**BEFORE THE ILLINOIS POLLUTION CONTROL BOARD**

| ILLINOIS ENVIRONMENTAL PROTECTION AGENCY, | ) | PCB 2025-061 |

**BEFORE THE ILLINOIS POLLUTION CONTROL BOARD**

# Main Plant Permitted Wells and Land Reuse Areas

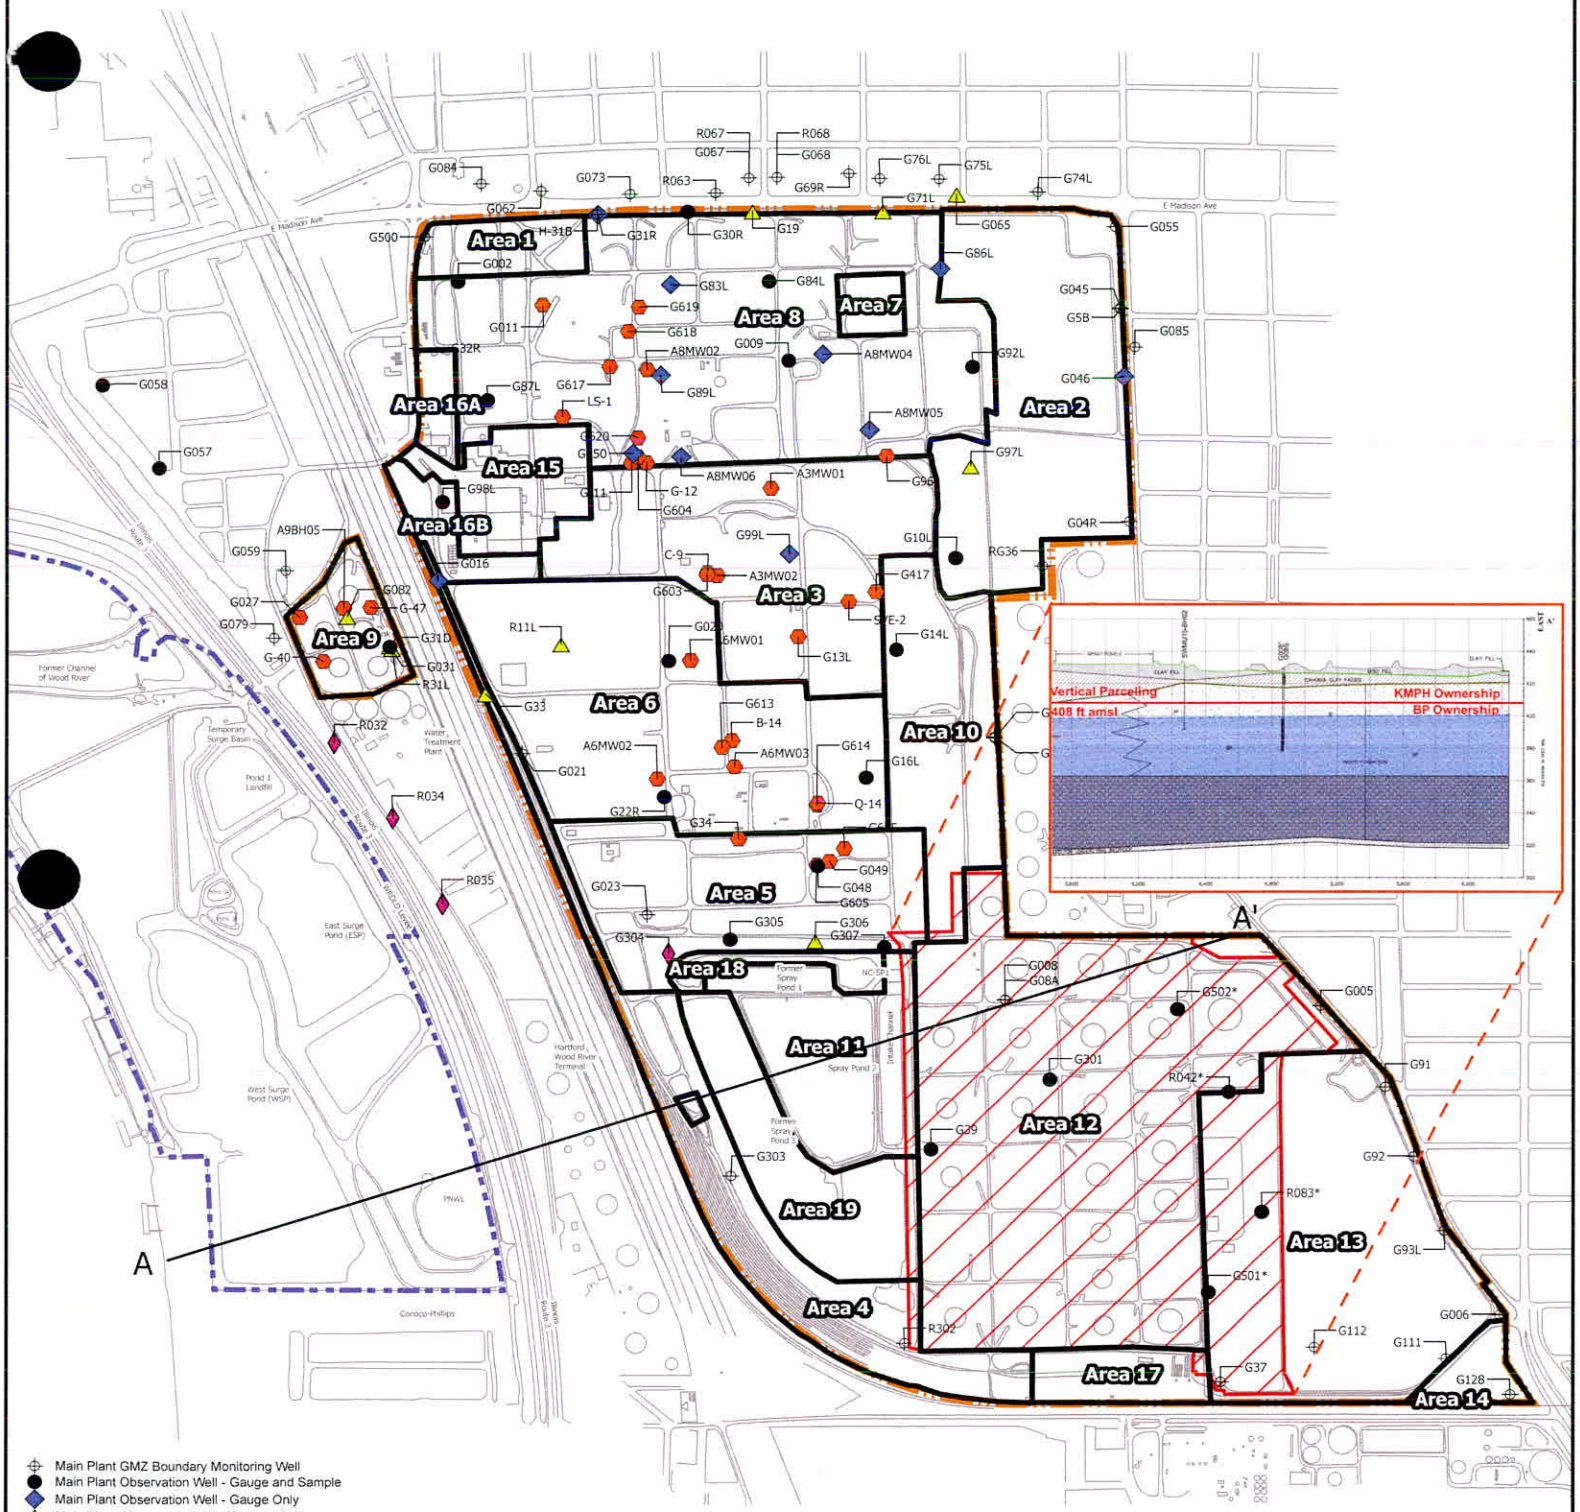
| IEPA COMMENT | BP RESPONSE |
|---|---|
| Figures C-4 and C-5 must be revised as they do not present the subsurface required to be addressed by BP beneath the Kinder Morgan property. It is recommended a cross-section be added to the figure. | Figure C-4 and Figure C-5 (which has been split into Figures C-5a and C-5b as noted under #10 below) have been revised to include a cross-section indicating the vertical parceling at 408 ft MSL.<br><br>Additionally, Table C-1 has been revised to reflect the optimized groundwater corrective action monitoring program approved by Illinois EPA in a letter dated January 19, 2023. |

**FIGURE C-5a**

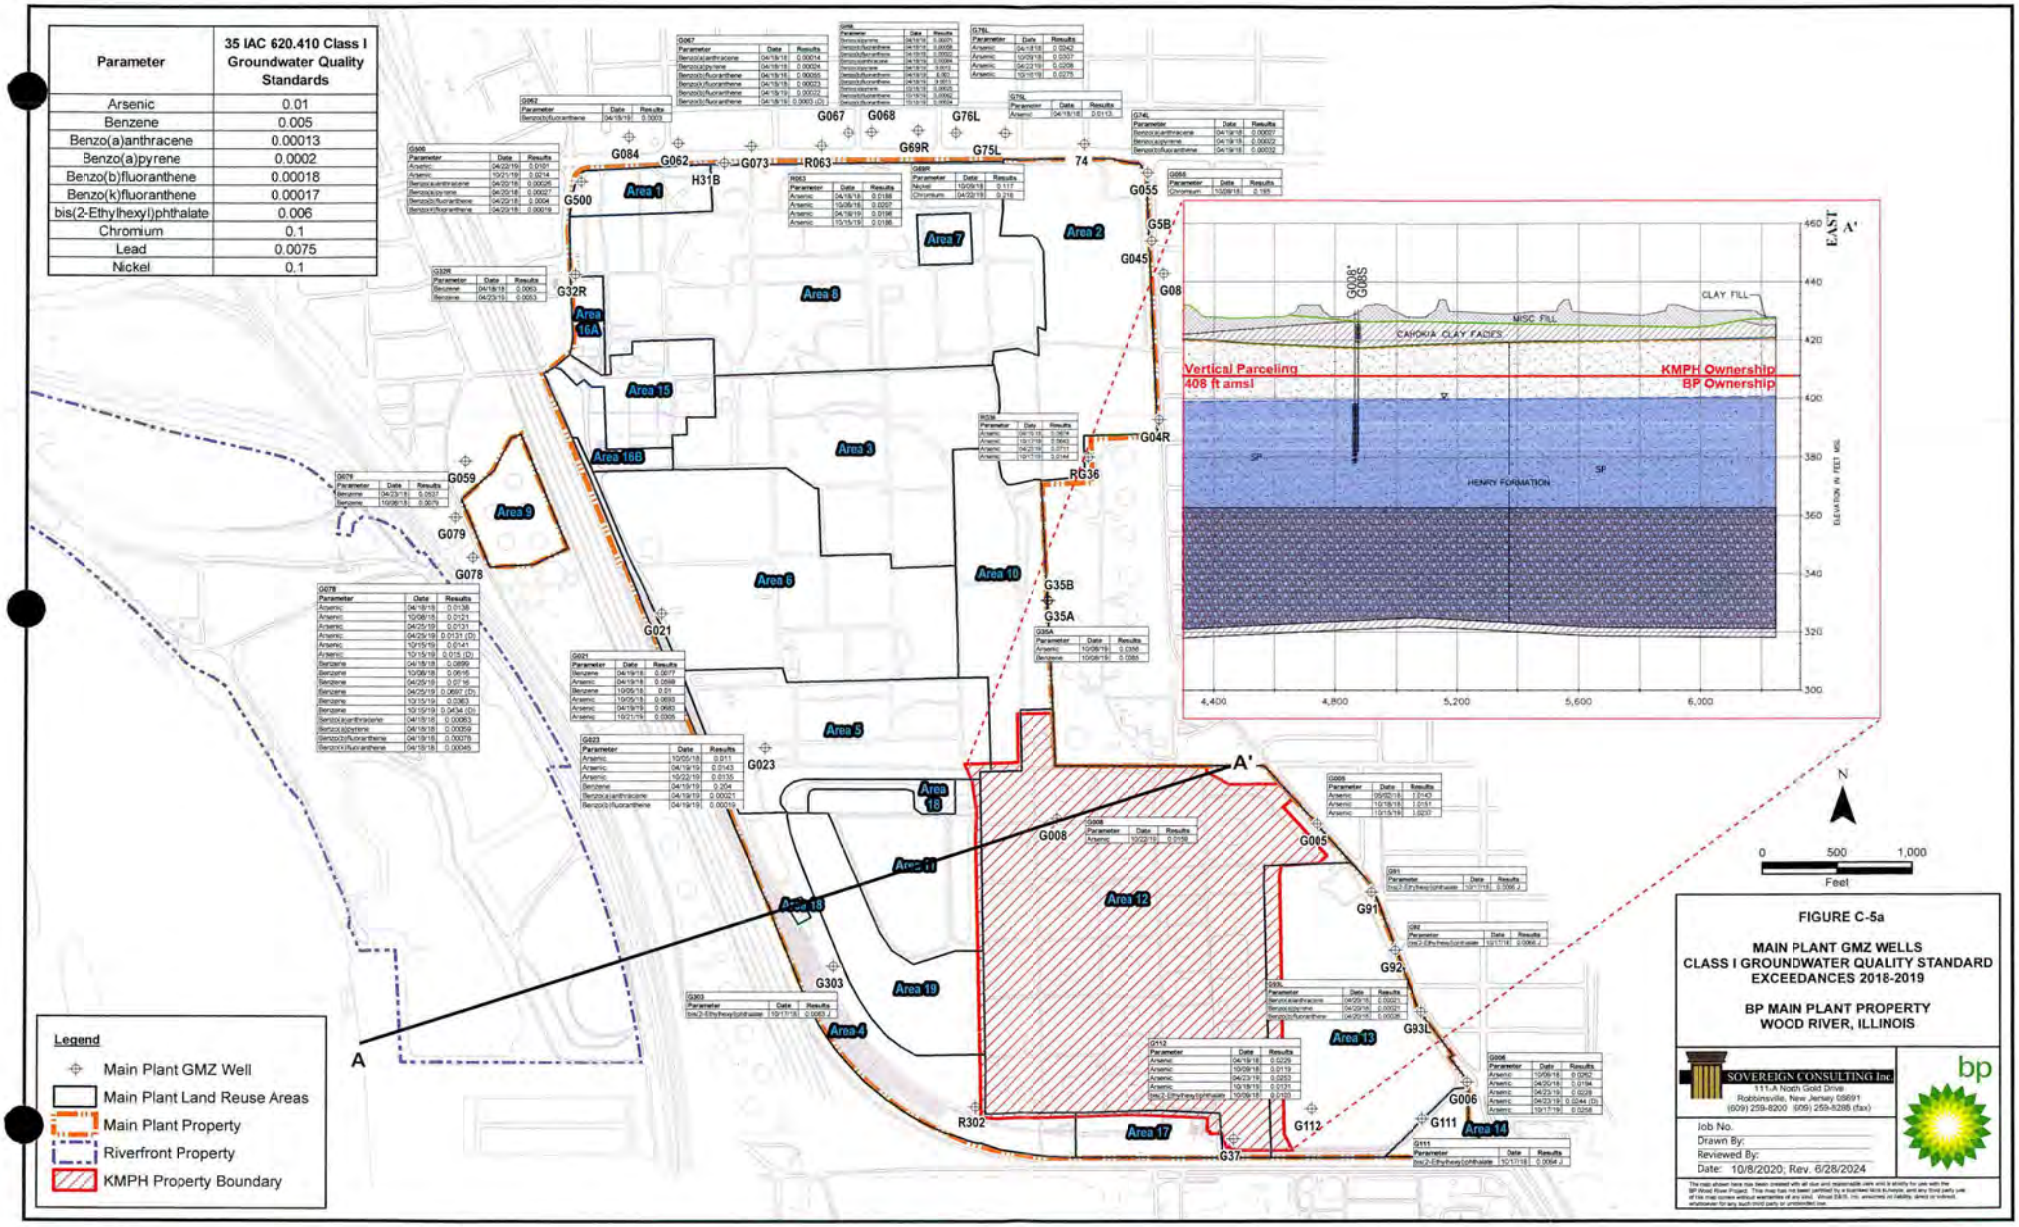
| IEPA COMMENT | BP RESPONSE |
|---|---|
| **10. Section C.8.1.1 and Figure C-5** | |
| Figure C-5 shows exceedances at Groundwater Management Zone (GMZ) boundary wells measured in 2018 and 2019. The boundary of a GMZ is intended to define the extent of a GMZ and groundwater quality at these wells should be at or below the Class I GQSs. Submit an additional figure to show any exceedances present over the last three (3) years of sampling. Continued exceedances at boundary wells may result in the requirement for additional corrective action. | The original Figure C-5 showing Class 1 GQS exceedances for 2018-2019 is now Figure C-5a. New Figure C-5b has been added showing Class I GQS exceedances for 2021-2023.<br><br>Additionally, the text in Section C.8 has been revised to include Class 1 GQS exceedances for 2021-2023 at wells located within each Land Reuse Area. |

FIGURE B-5A

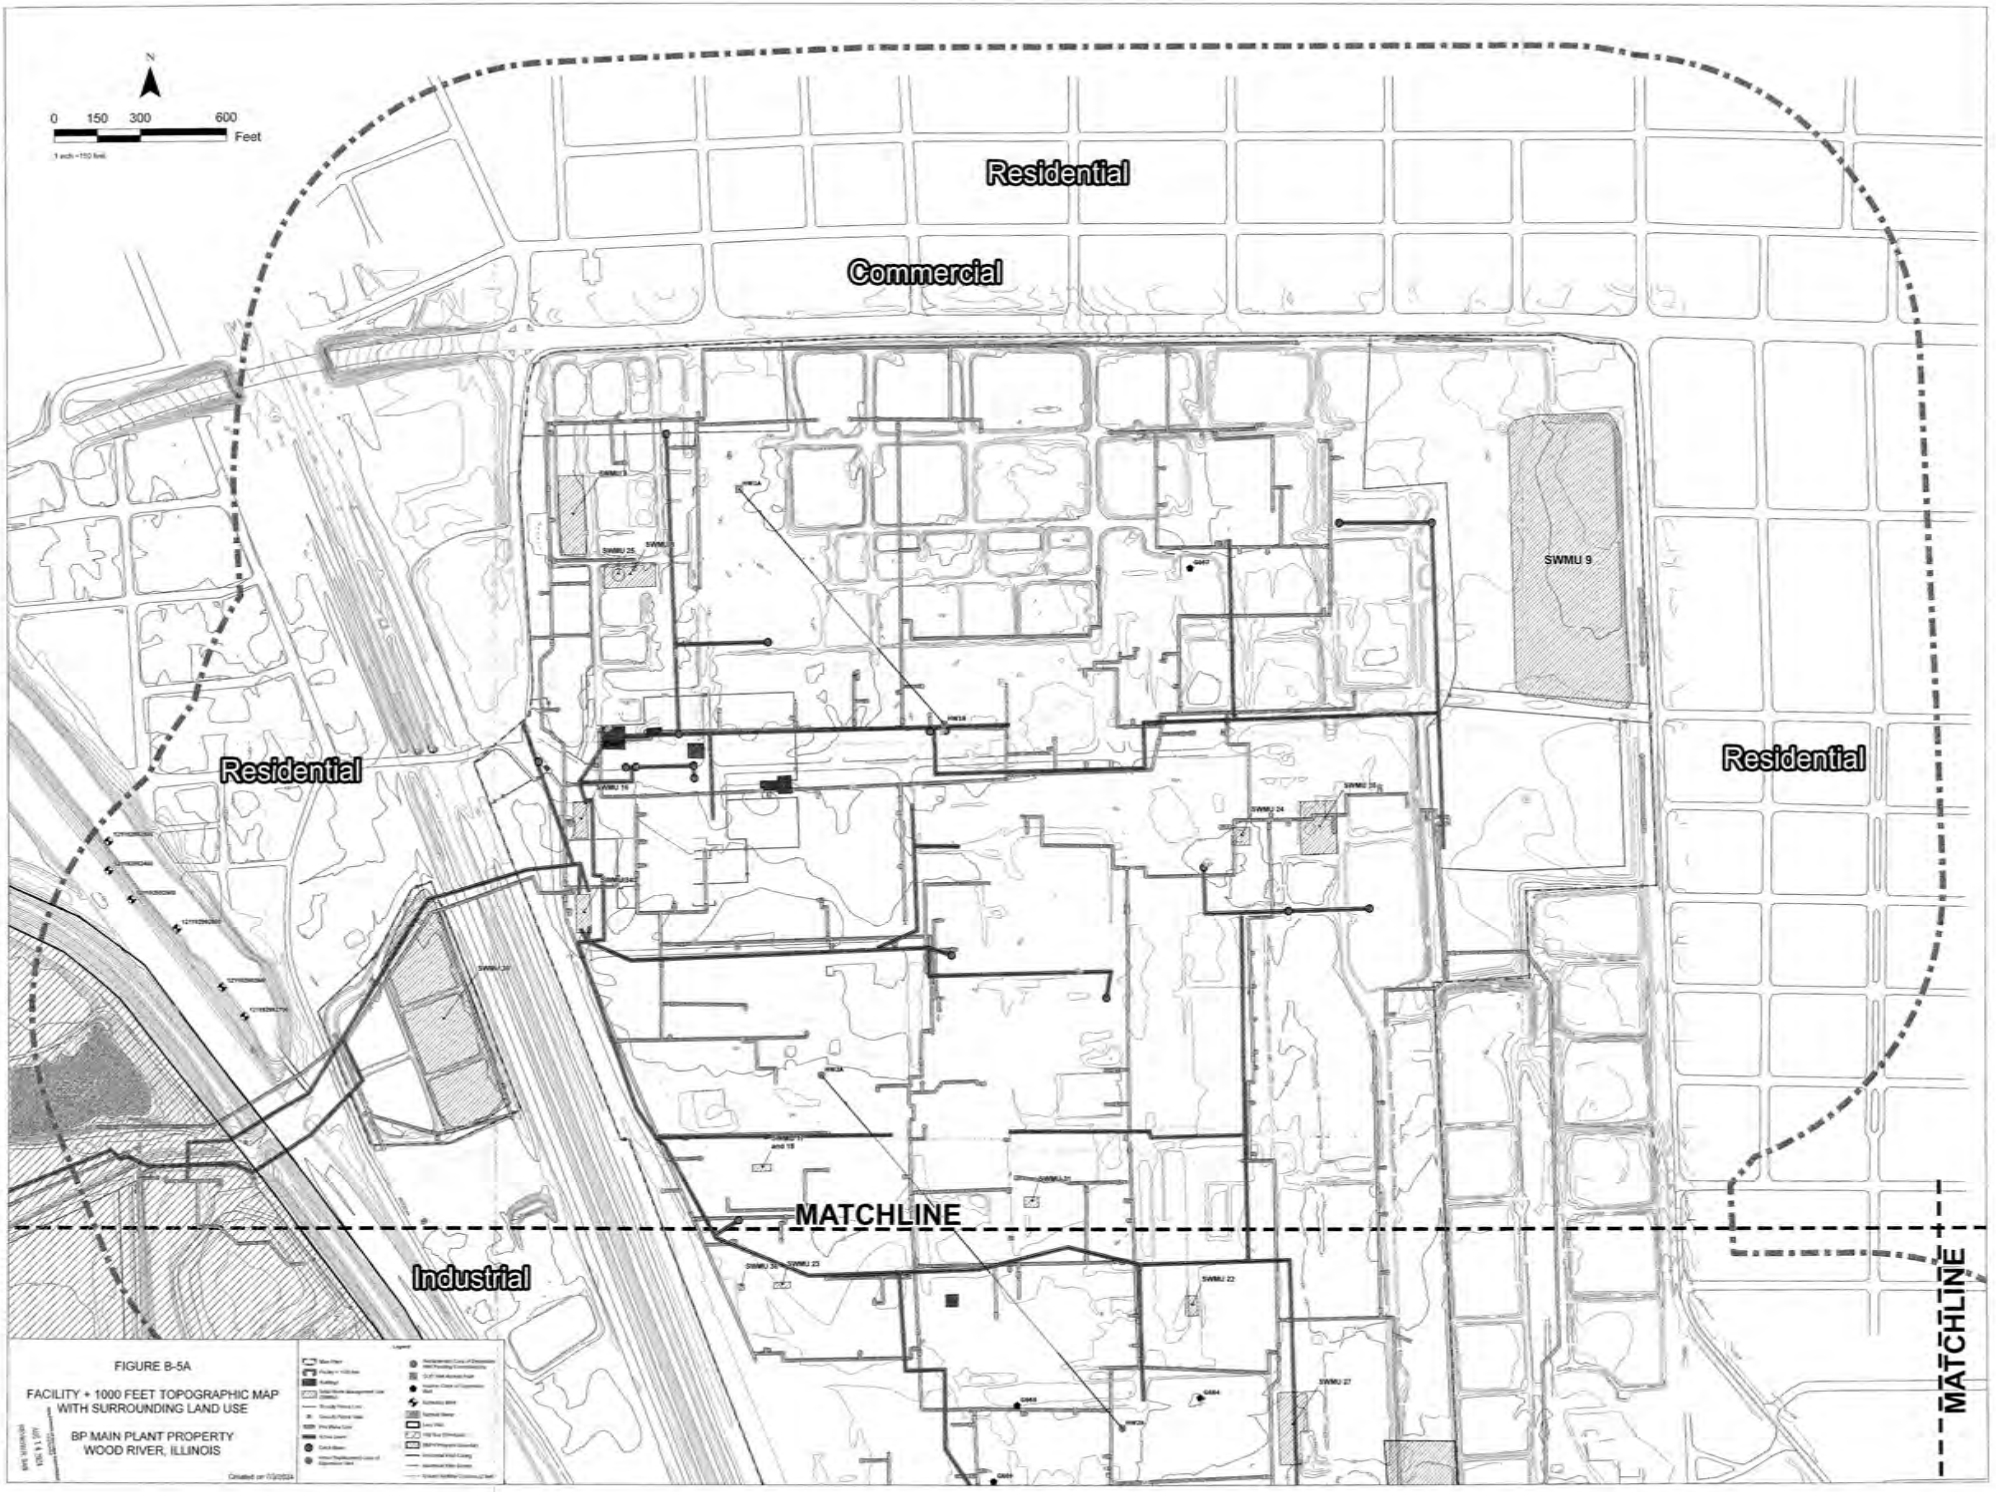
| IEPA COMMENT | BP RESPONSE |
|---|---|
| Revise the Facility + 1000 feet topographic map to include all the information listed in Illinois EPA's Guidance Document (i.e., map date, access controls, contour map interval, storm drains, flood control or drainage barriers). Provide justification if any of the required items are not applicable. Provide an updated wind rose for this site, the one in the application appears to be outdated (dated March 3, 2007). | The Facility + 1,000 feet Topographic Maps (Figures B-5A, B-5B, and B-5C) have been revised along with Section B.2.2. These maps include applicable items listed in the Map Requirements: Facility +1,000 Feet table of the *Information Required in an Application for a RCRA Post-Closure Permit*. Figures B-5B and B-5C have been revised to include removal of the KMPH property from Area 12 and clearly describe or illustrate the vertical parceling (i.e., KMPH ownership from ground surface to 408 ft AMSL and bp ownership below 408 ft AMSL).<br><br>Exhibit B-2 has been revised to include an updated wind rose diagram dated June 25, 2024, including data from June 1, 2014, through June 25, 2024. |

- The Facility + 1,000 feet Topographic Maps (Figures B-5A, B-5B, and B-5C) have been revised to include requested information and the KMPH property has been removed from Area 12 and clearly describes or illustrates the vertical parceling.
